## **Update to AC8000/1 Manual**

- **New Board – Revision 5 Series F**
- **New Printer – Seiko**
- **New Software – P\_2A\_C00**

**Revision 5 F Series Board**  
**F in the Serial Number Identifies it!**  
**Software version P\_2A\_C00**  
**Started shipping 5/25/04 with Seiko printer.**

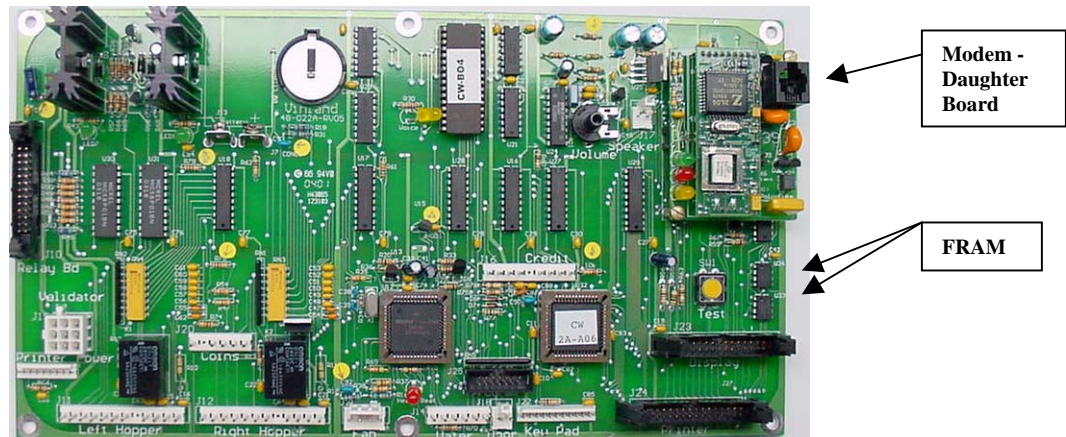
1. Additional memory has been added.
2. All critical information is stored in non-volatile memory.
3. The modem has been mounted on a removable daughter board, allowing for development of different communication ports for future applications.
4. A new printer (Seiko) is being used, that is mounted to the door for easier access and loading.
